Project
BARANGAROO STAGE 1B
PUBLIC DOMAIN
Modification S4.55

Drawing Title
HICKSON PARK SOUTH
ENTRY DETAIL PLAN - NO
TREES
Drawn
SS

Drawing Number
BAR-418-DA-HP-DP04
Checked
MW

Drawing Title
WULUGUL WALK
SECTION E - E
Drawn
SS

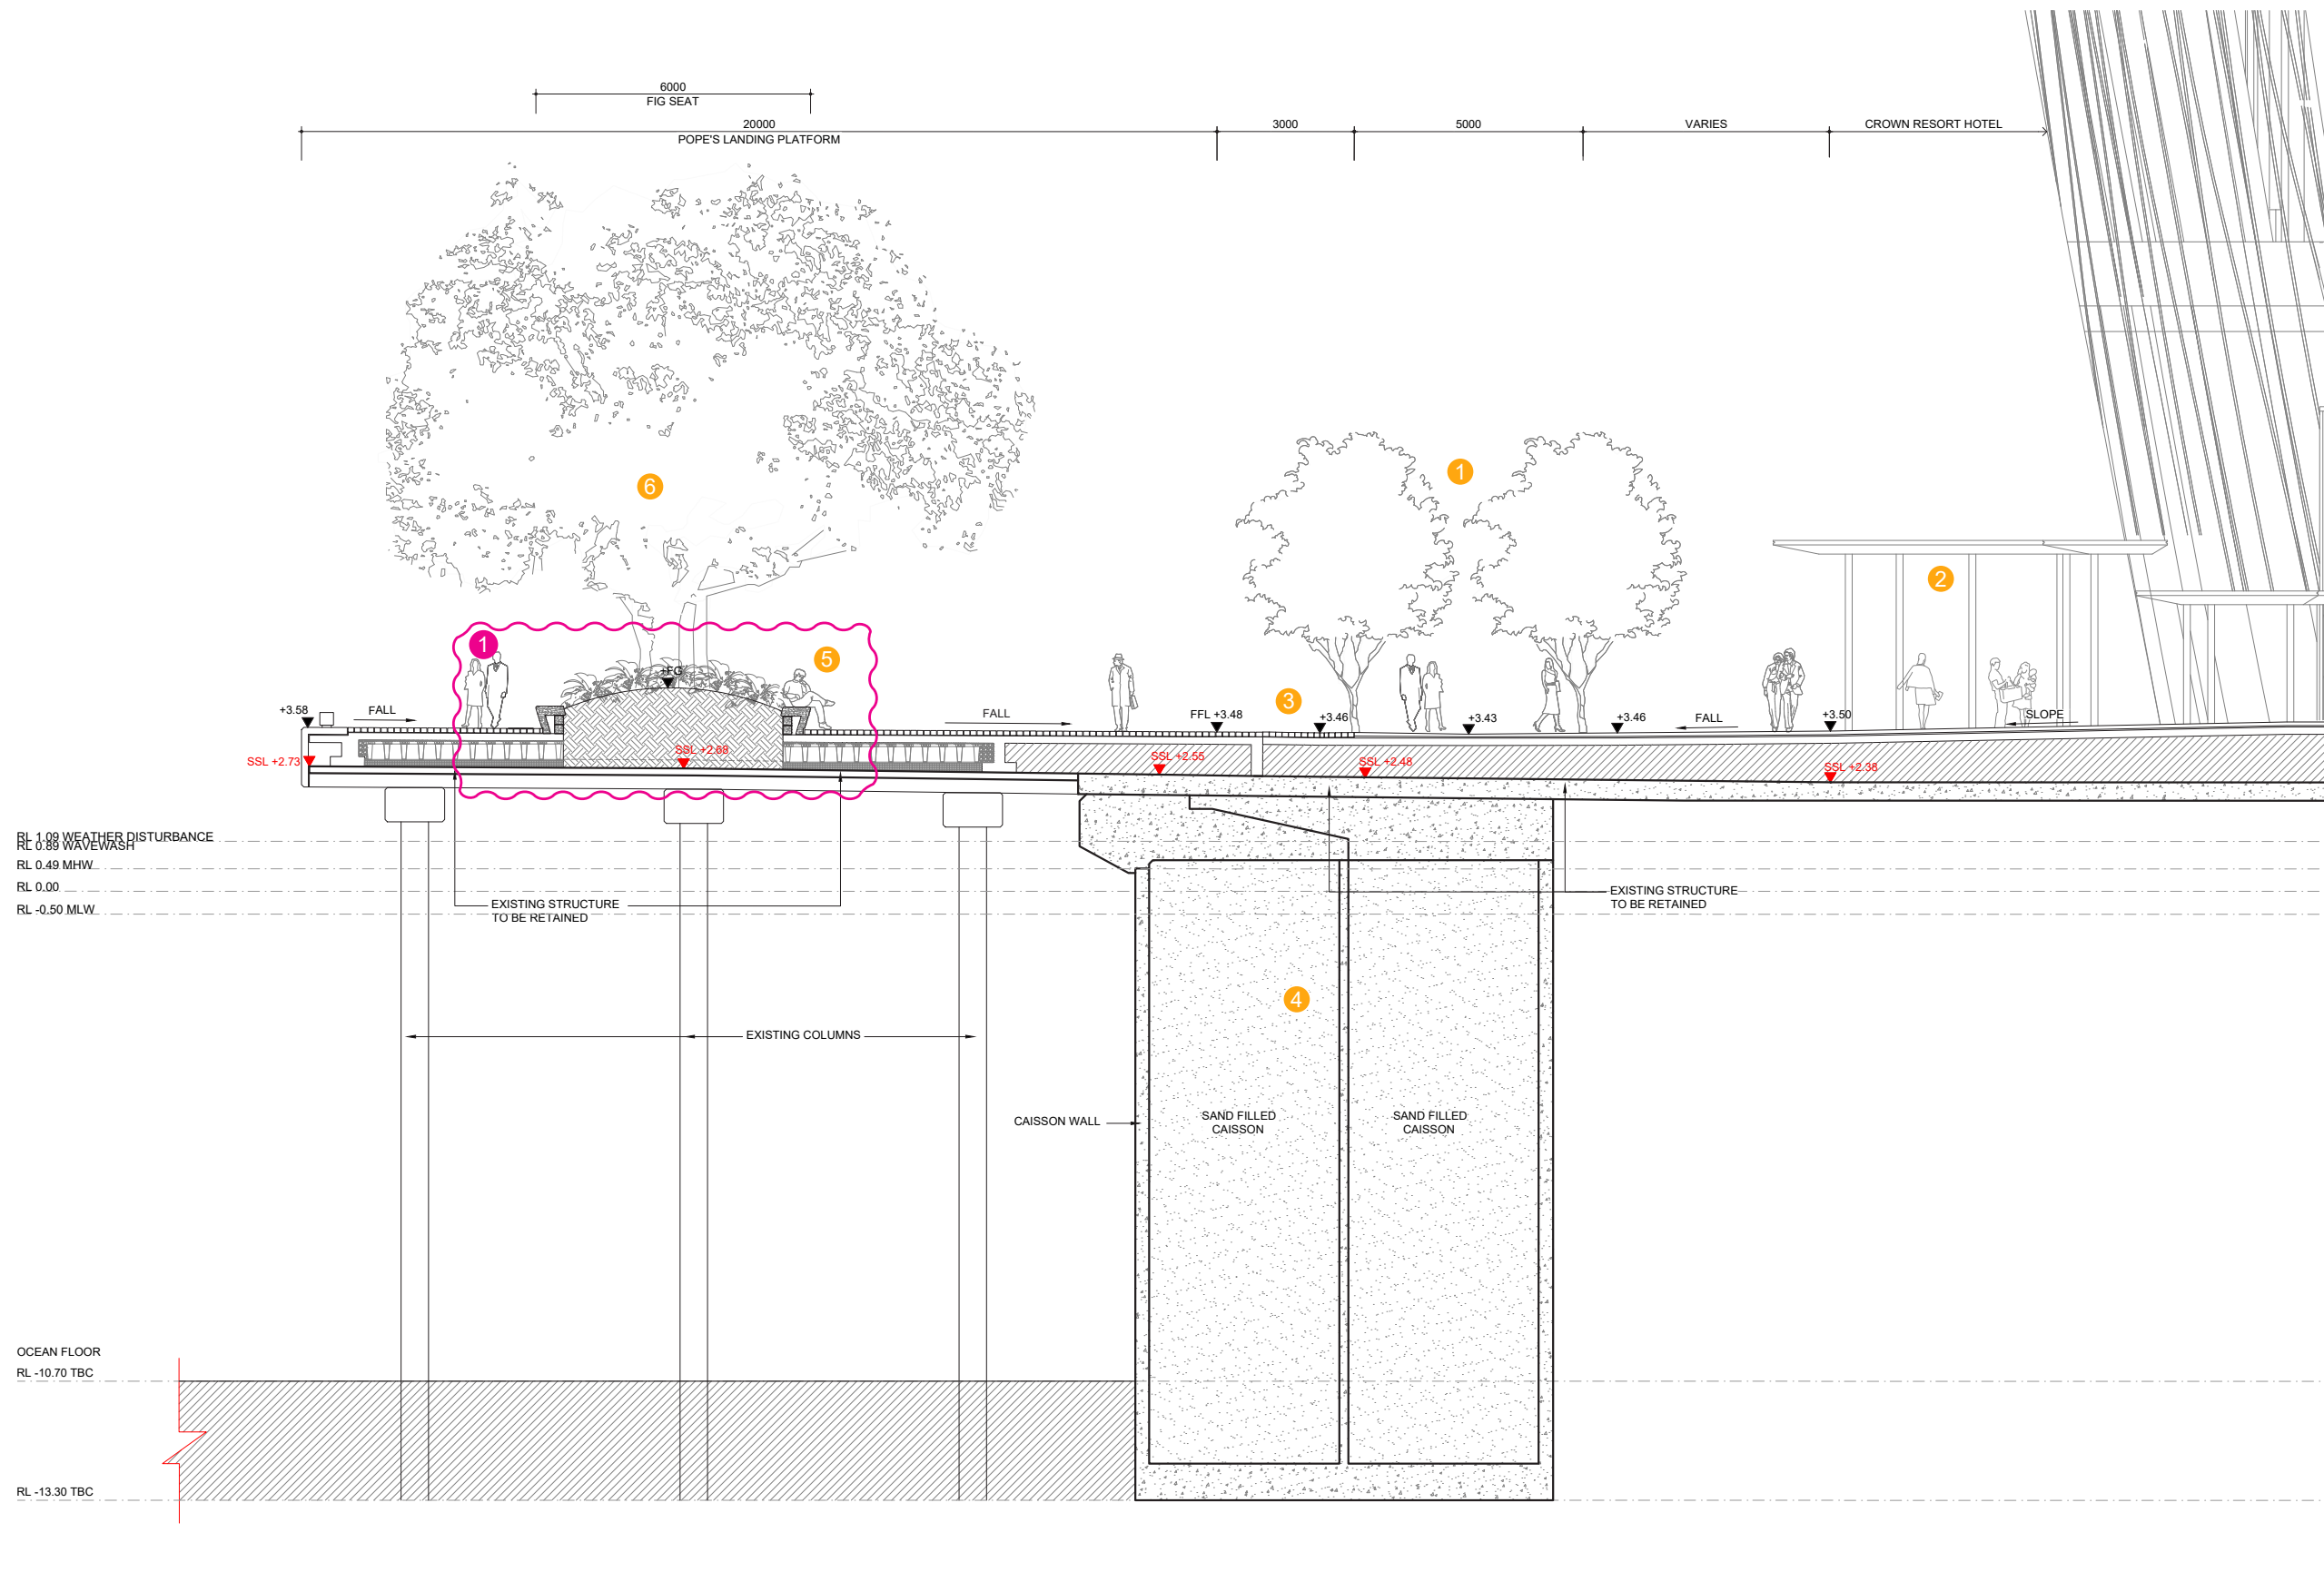
- Amendment cloud
- 1 Remove timber top for Sprit of Tasmania loading dock raised planter seating

Drawing Title
WATERMANS COVE
MASTERPLAN - NO TREES
Drawn
SS

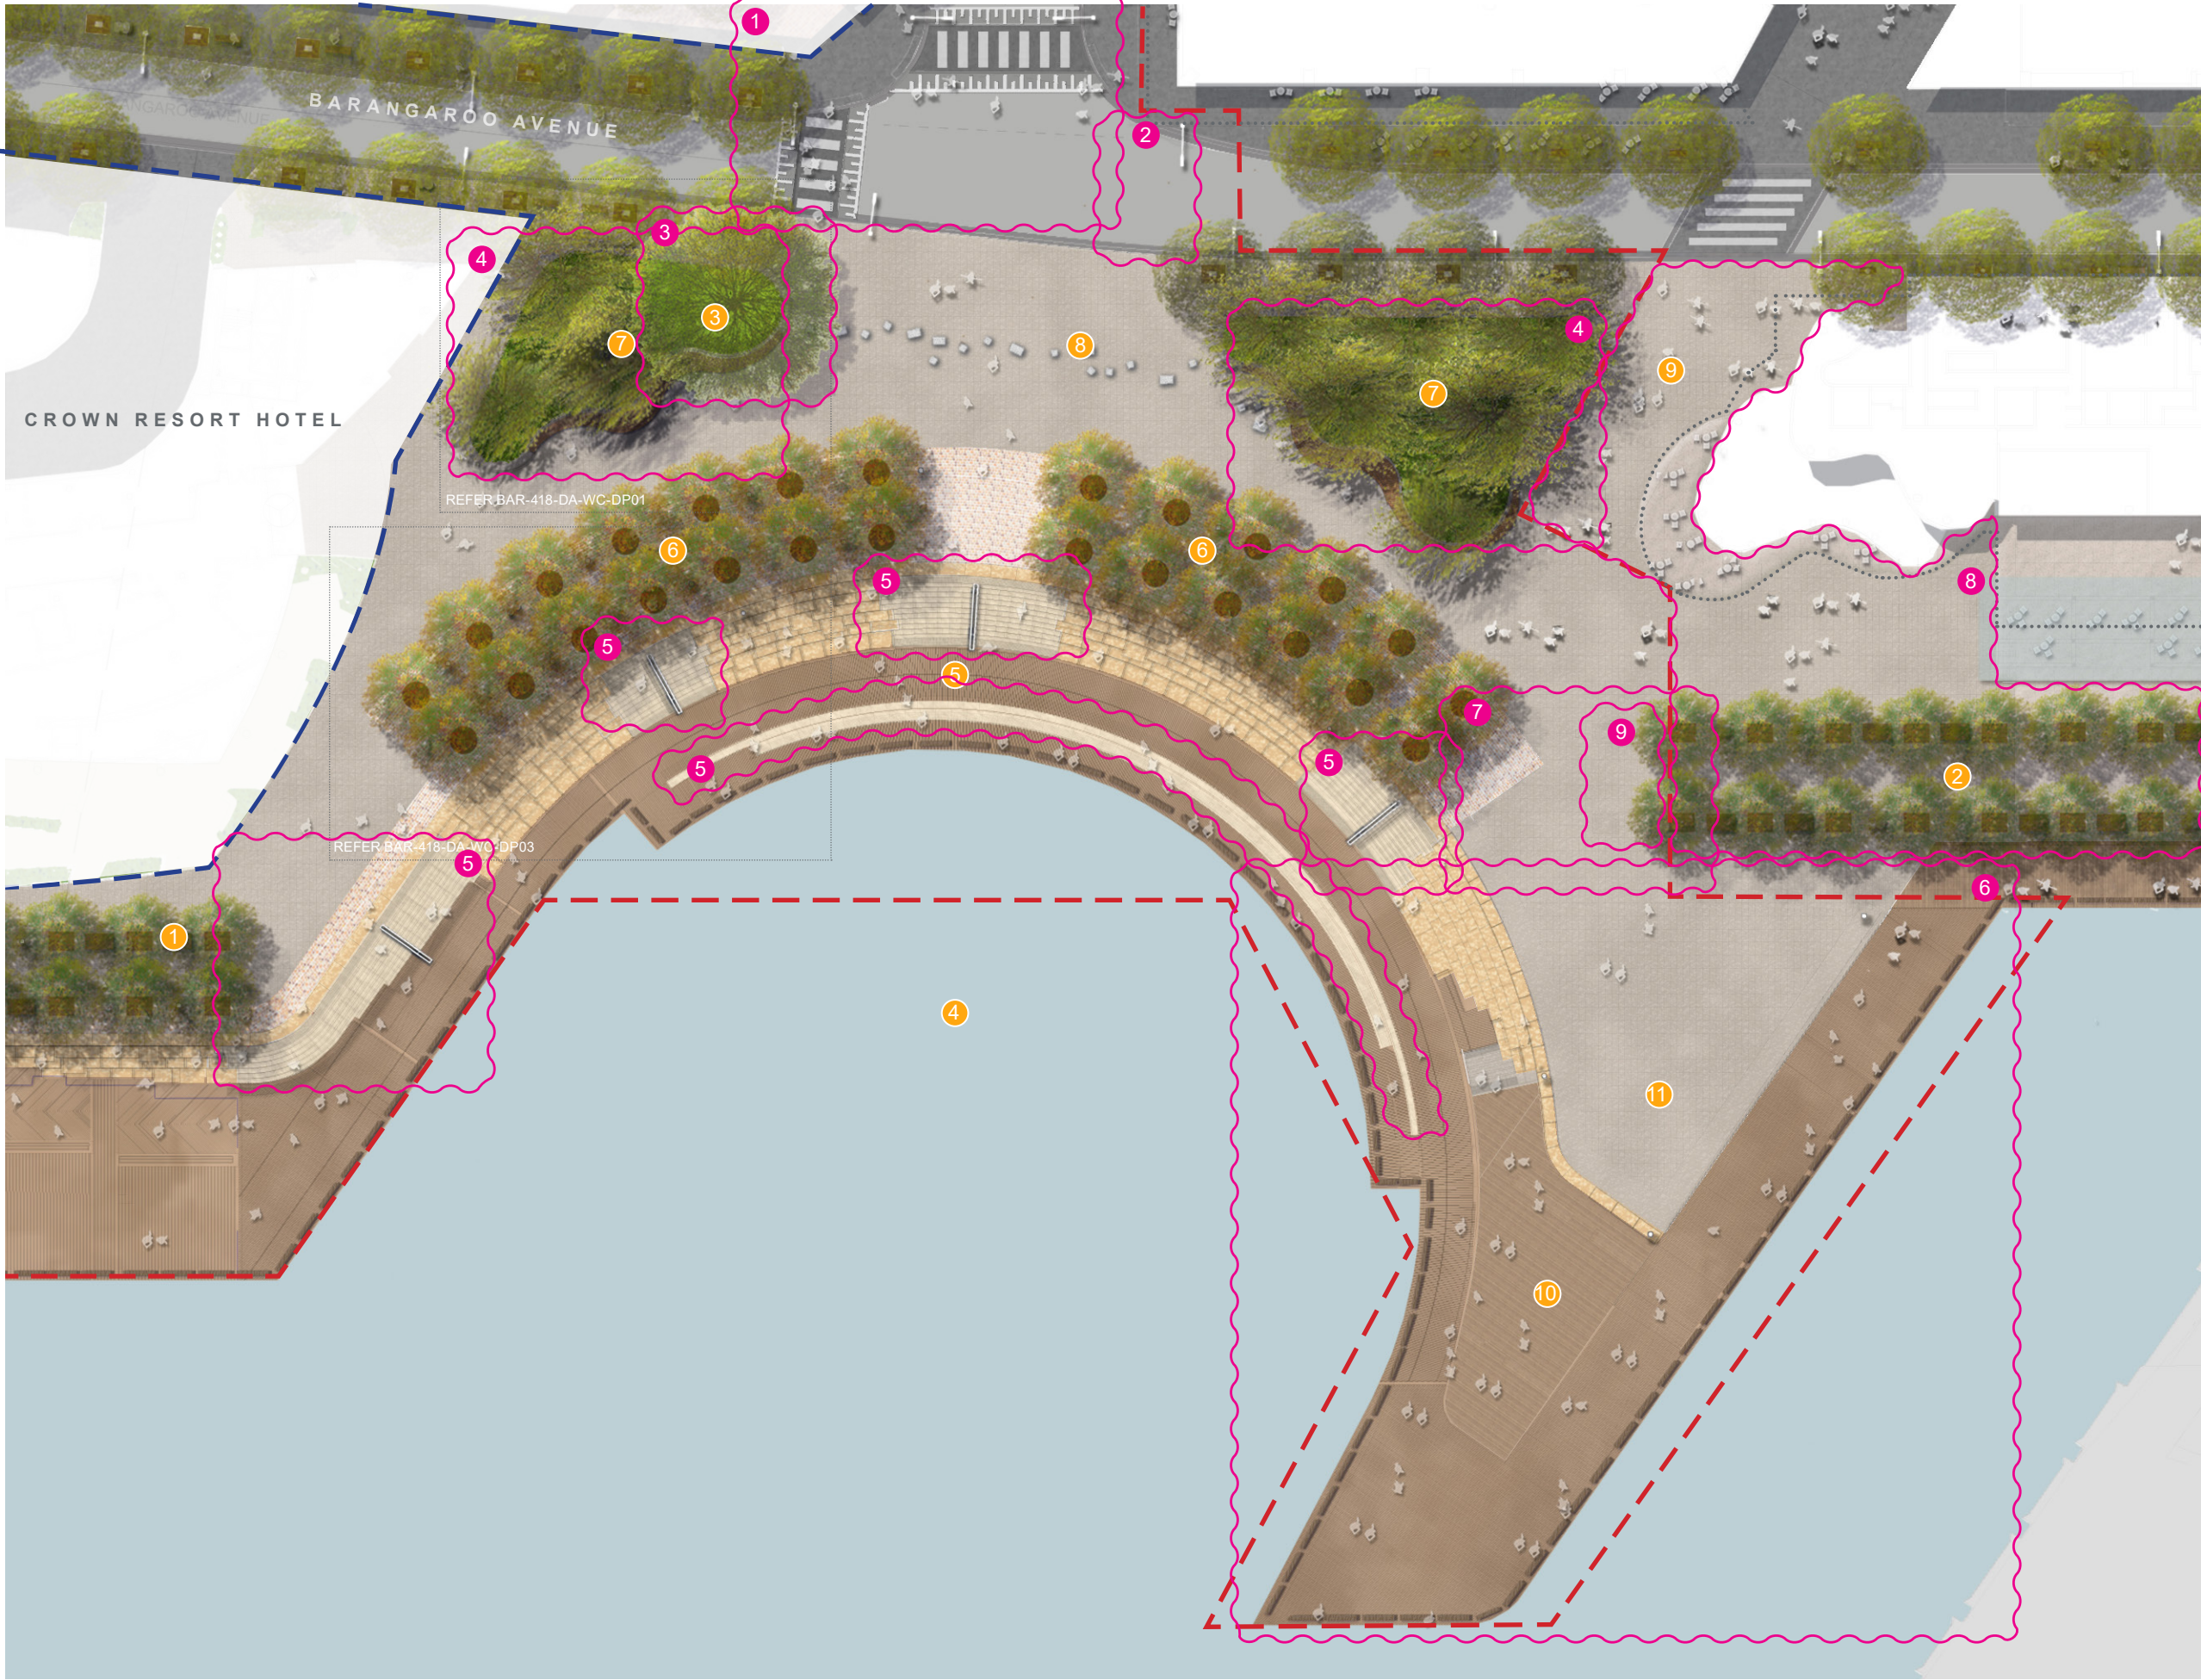
- Proposed Modifications**
- Amendment cloud
 - 1 Change to raised pedestrian crossing
 - 2 Deletion of pedestrian crossing
 - 3 Relocated Fig tree to North raised planter
 - 4 Change geometry of raised planter/reduce raised planter timber top and remove timber backrest
 - 5 Stone stairs changed to concrete
 - 6 Pier re-design: change to 3 tiers design
 - 7 Stop porphyry paving at the top of the last Southern stair
 - 8 Stage 1A design modification to suit Stage 1B proposal. Subject to separate approval.
 - 9 Removal of 2no. Celtis australis to respond to pier amendment

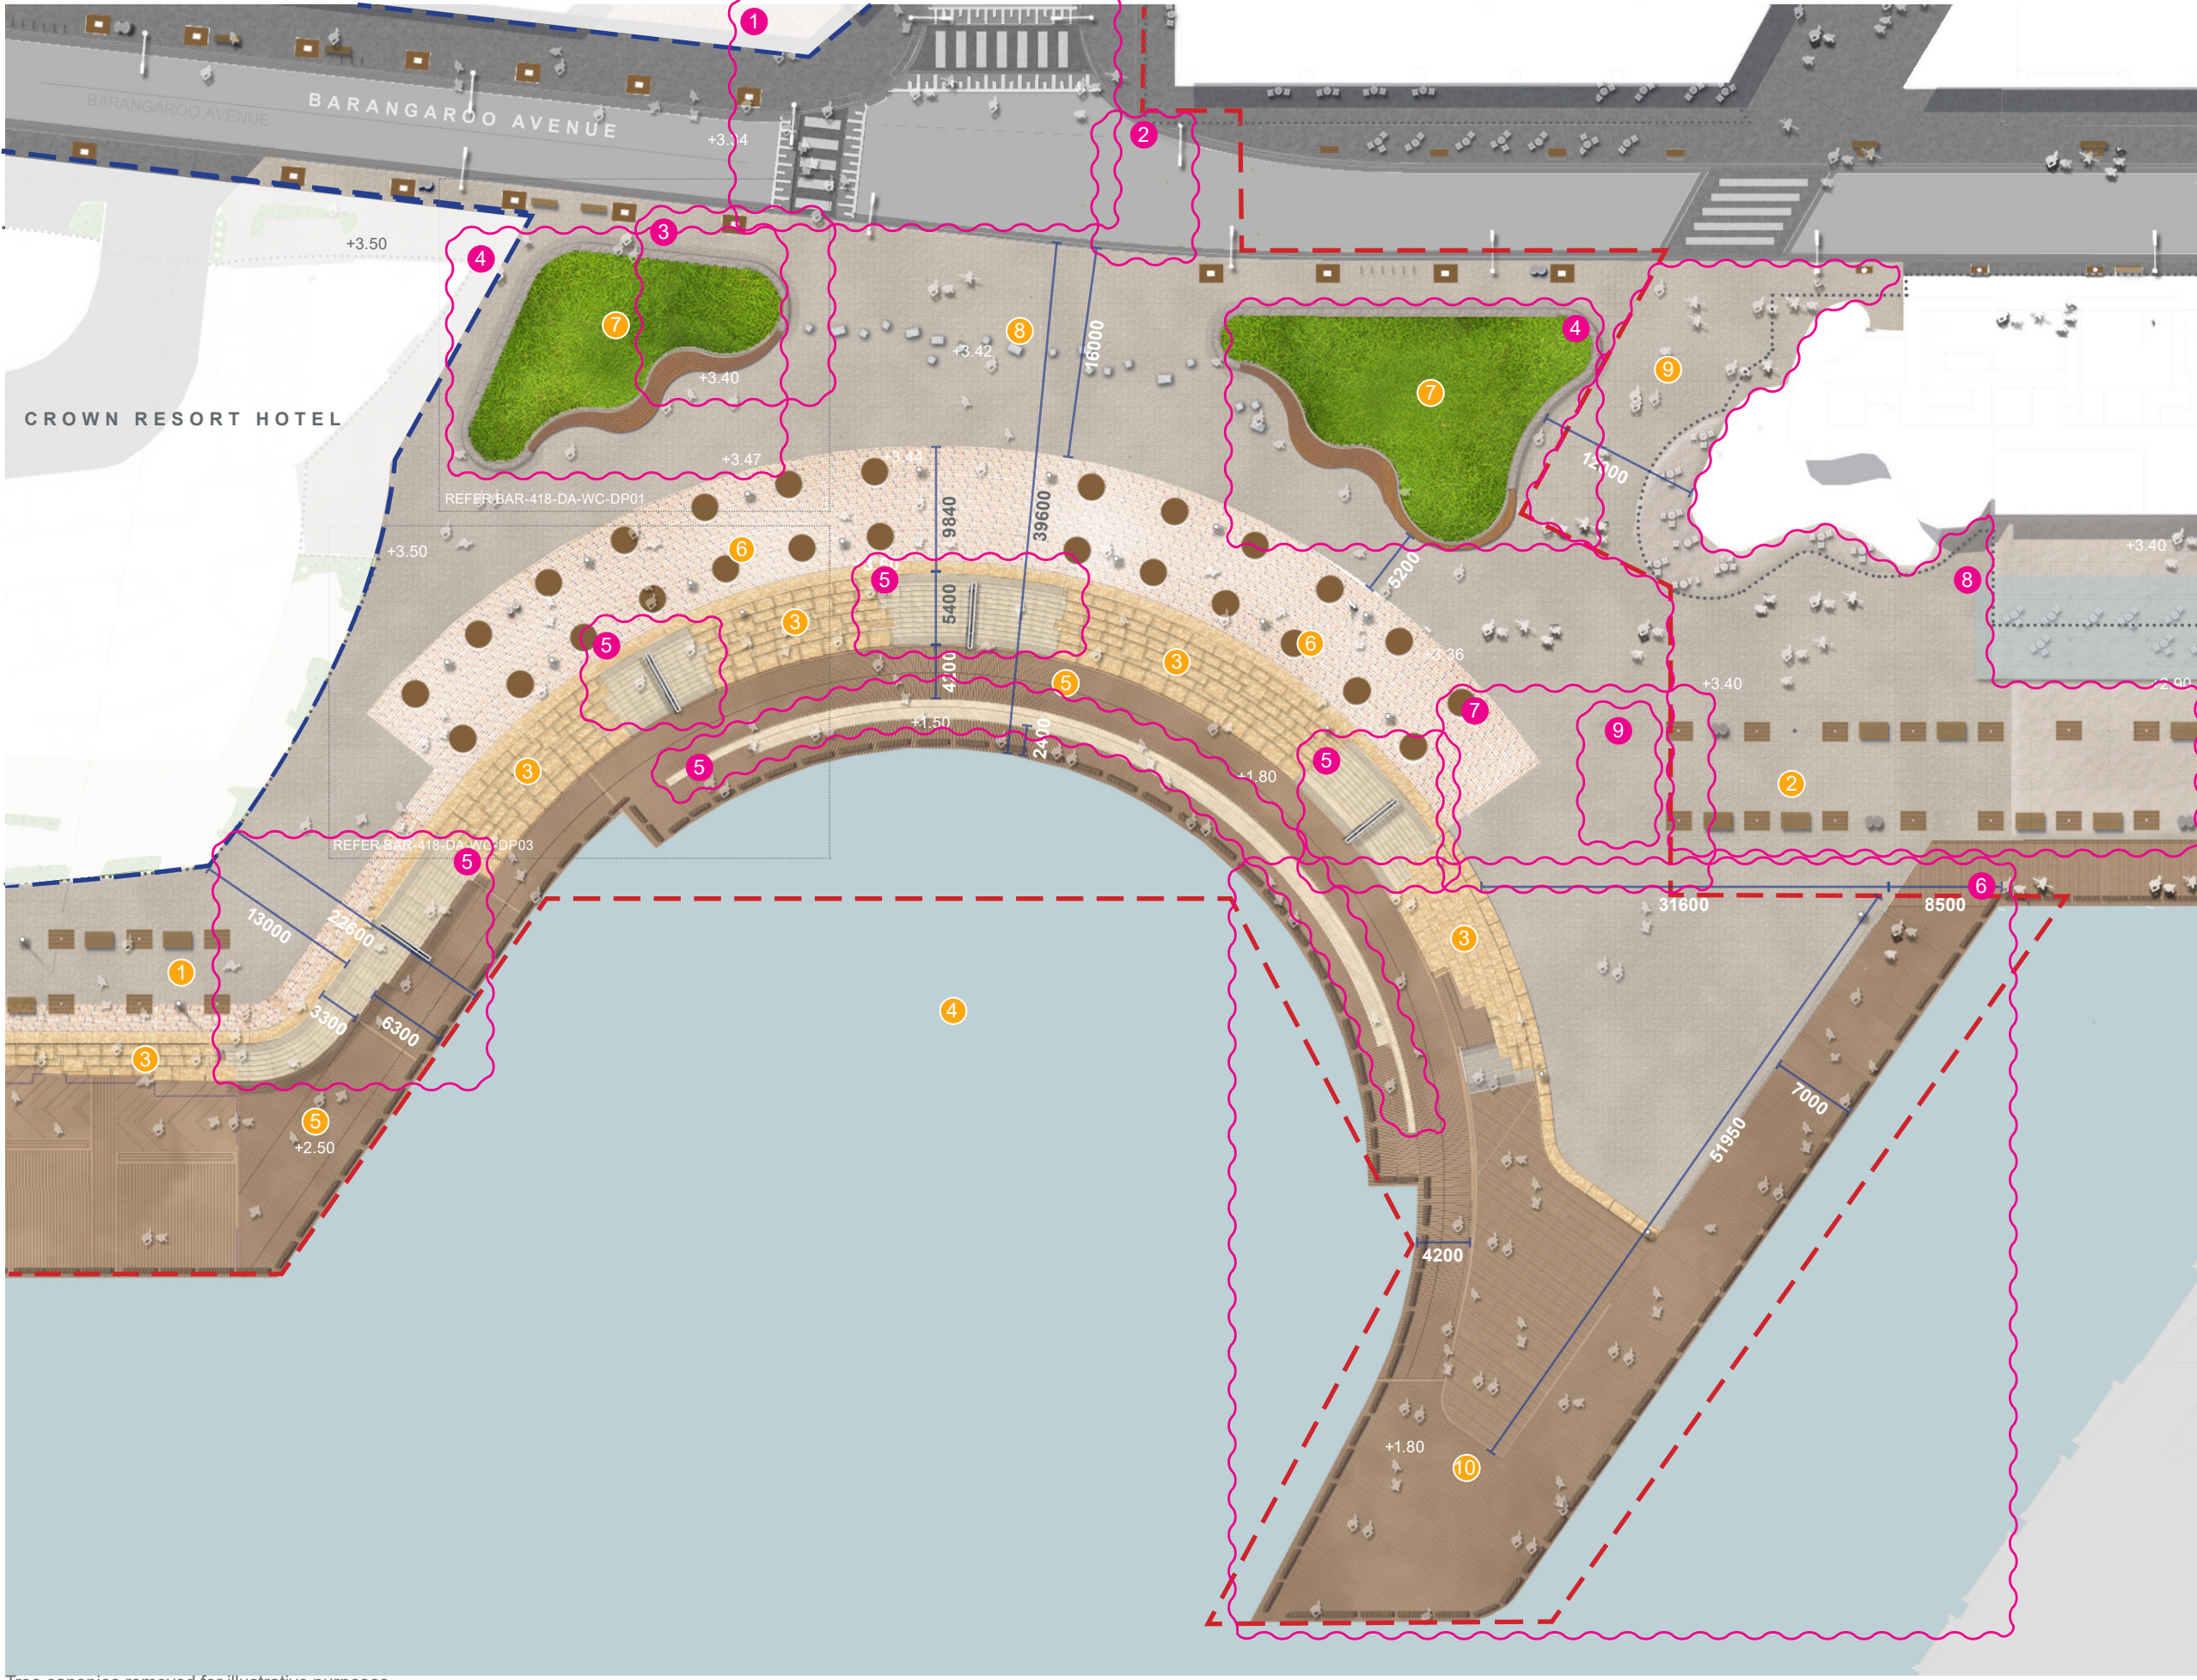
- Amendment cloud
- 1 Change to raised pedestrian crossing
- 2 Deletion of pedestrian crossing
- 3 Relocated Fig tree to North raised planter
- 4 Change geometry of raised planter/reduce
raised planter timber top and remove timber
backrest
- 5 Stone stairs changed to concrete
- 6 Pier re-design: change to 3 tiers design
- 7 Stop porphyry paving at the top of the last
Southern stair
- 8 Stage 1A design modification to suit Stage 1B
proposal. Subject to separate approval.
- 9 Removal of 2no. Celtis australis to respond to
pier amendment
